RE: Data Response, Set 1A
Ivanpah Solar Electric Generating System (07-AFC-5)

Ivanpah Solar Electric Generating System (ISEGS)

Data Response, Set 1A

(Response to Data Requests 1 through 116)

FIGURE DR80-1c
IVANPAH 1
MAJOR HYDROLOGIC FEATURES
IN AND NEAR THE PROJECT SITE
 IVANPAH SOLAR ELECTRIC GENERATING SYSTEM

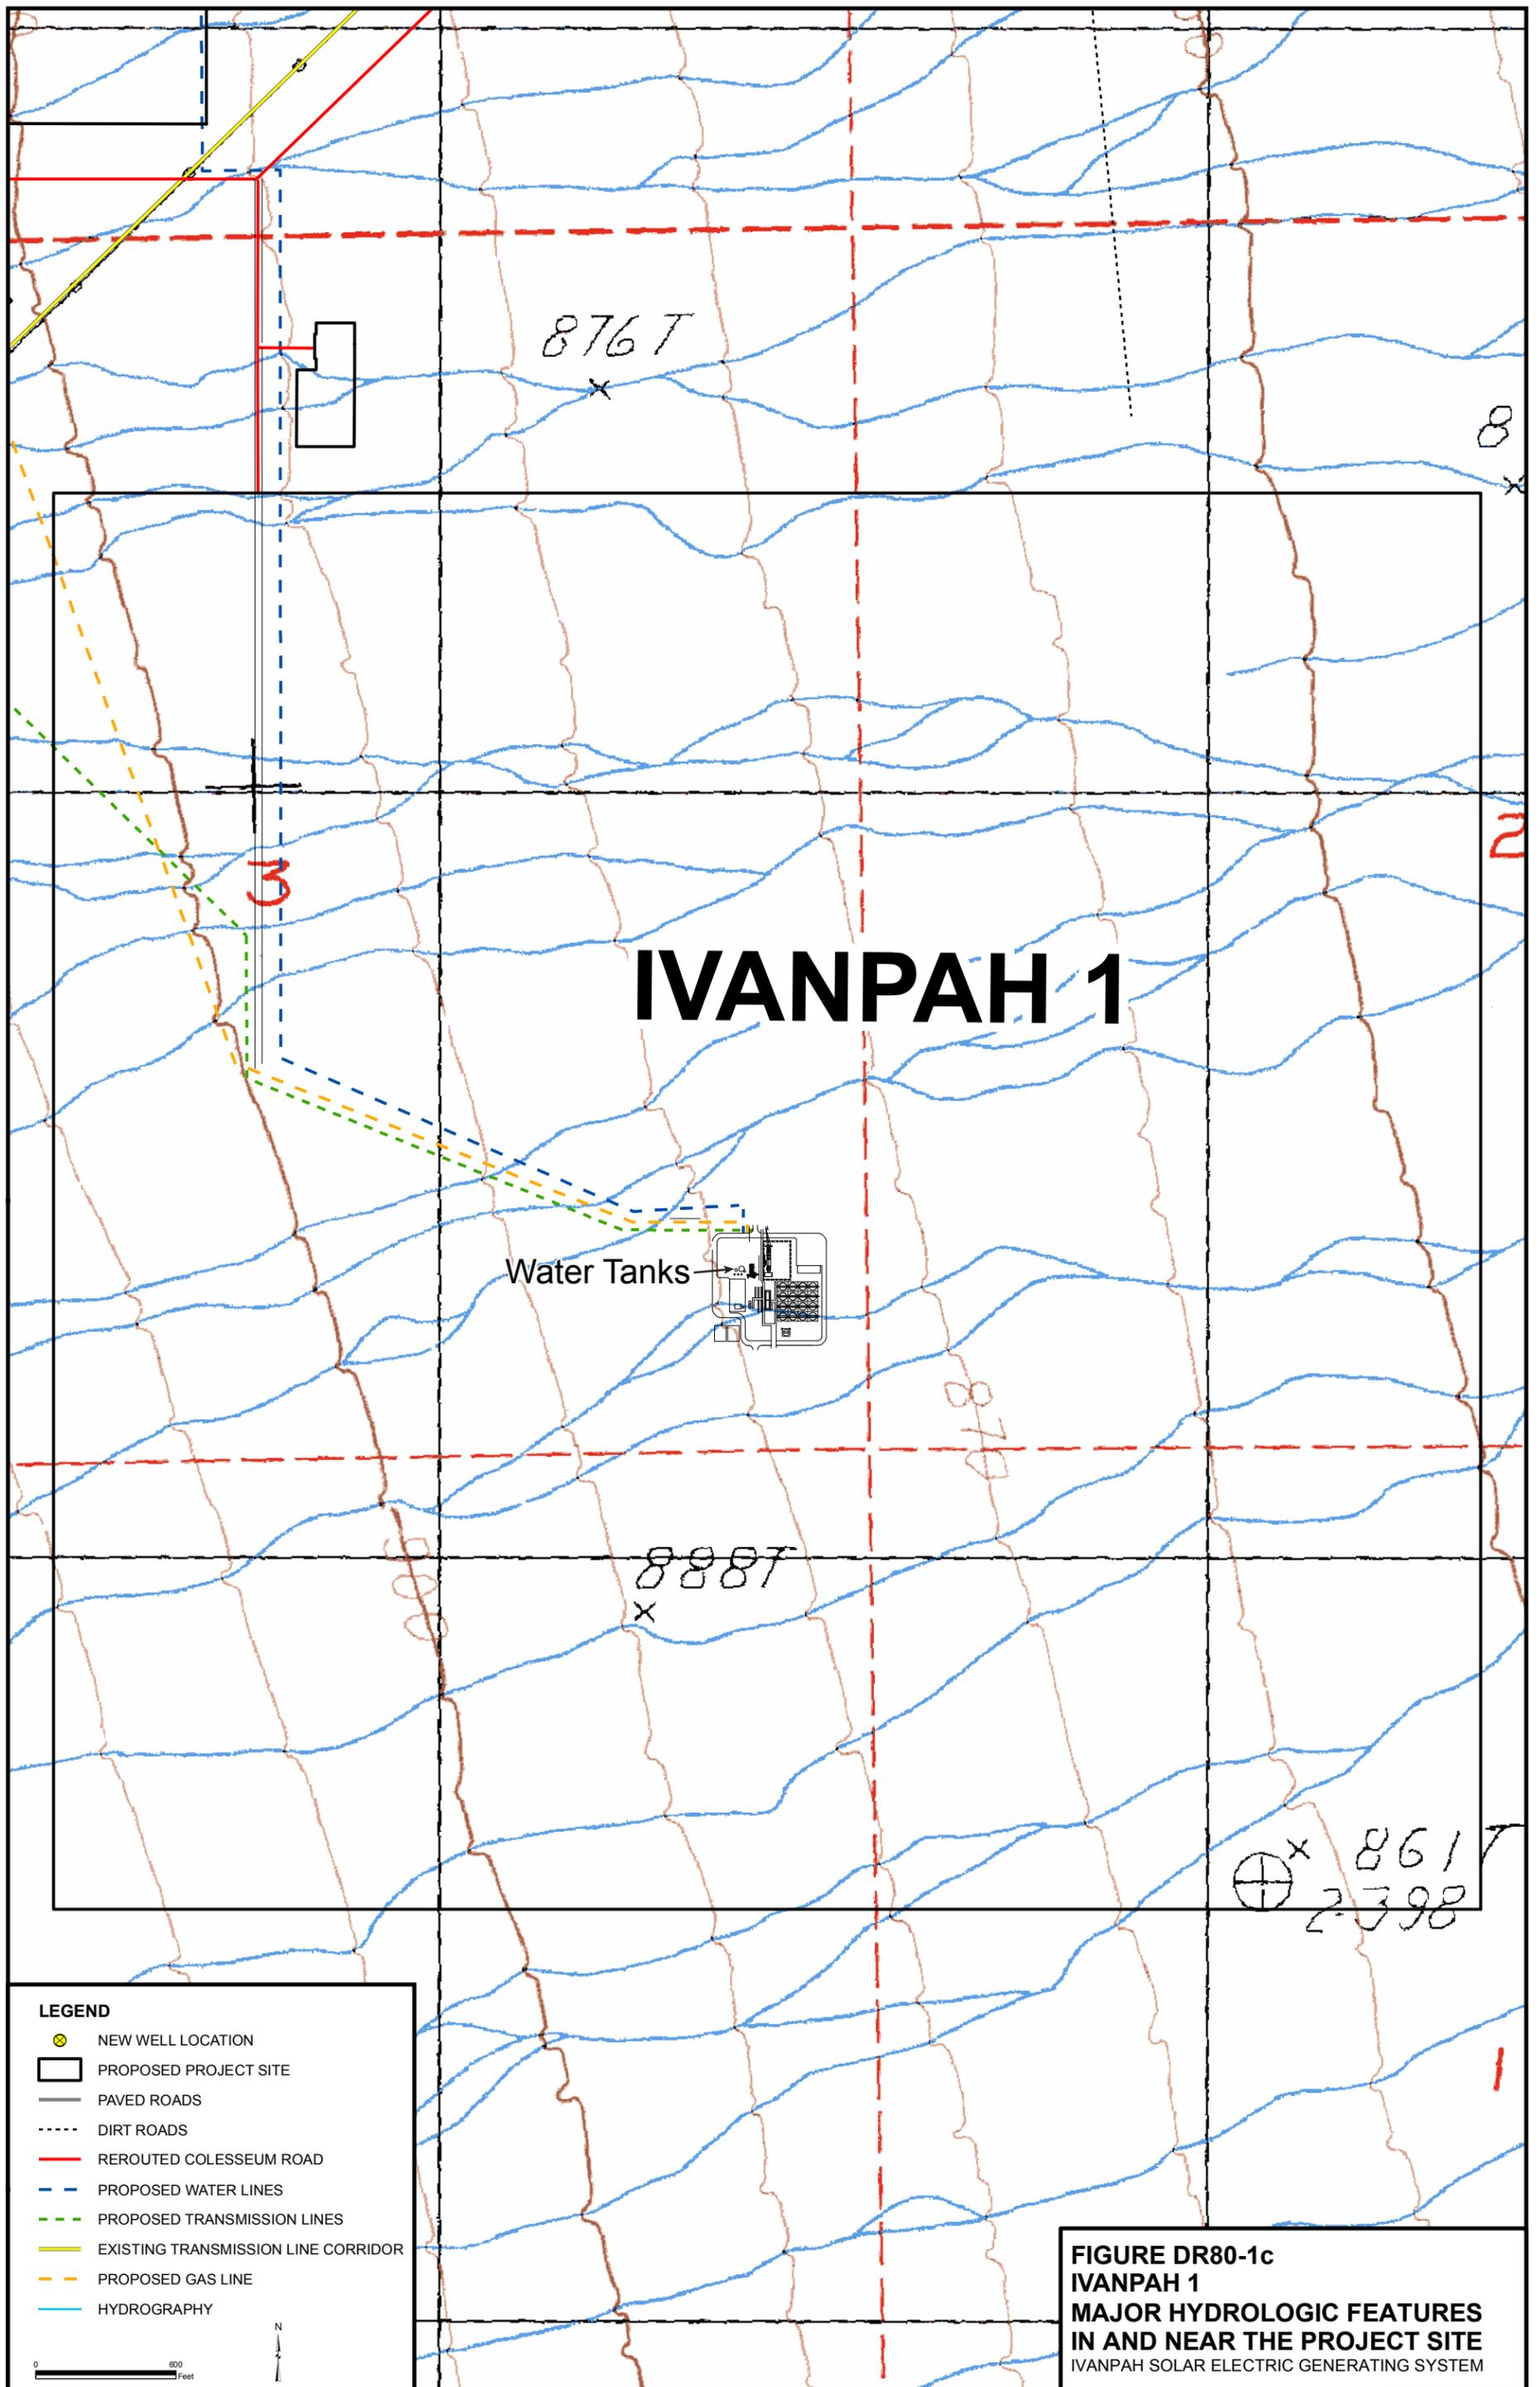
80. Please show the location of the proposed water tanks and distribution lines on a revised Figure 5.15-2 (Major Hydrologic Features In and Near the Project Site).

Response: The scale of AFC Figure 5.15-2 has been revised to allow the power block to be shown. Each phase is shown in a separate figure. Figure DR80-1a is Ivanpah 3, Figure DR80-1b is Ivanpah 2, and Figure DR80-1c is Ivanpah 1. The location of the water tanks is indicated on each figure.
